PCN #: 2542

PCN Title: Qualification of Additional Clip Bonding, Lead Frame Structure (Matrix) and Mold Compound for Select Discrete Products in SMA Package

PCN-2542 REV 1

Figure 1: Comparison of Package Construction for Schottky, SBR, GPP Rectifiers, Zener, and Unidirectional TVS products

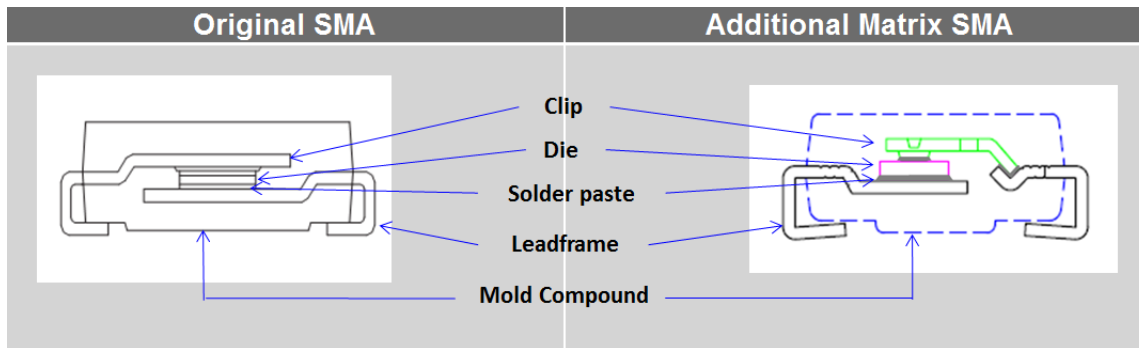
This PCN is being issued to notify customers that in order to assure continuity of supply and to improve SMA package manufacturability, Diodes Incorporated has qualified additional clip bonding, lead frame structure (Matrix) and mold compound at Diodes subcontractor Eris Technology Corp. (ERIS) in Taiwan for select Discrete products in SMA package.
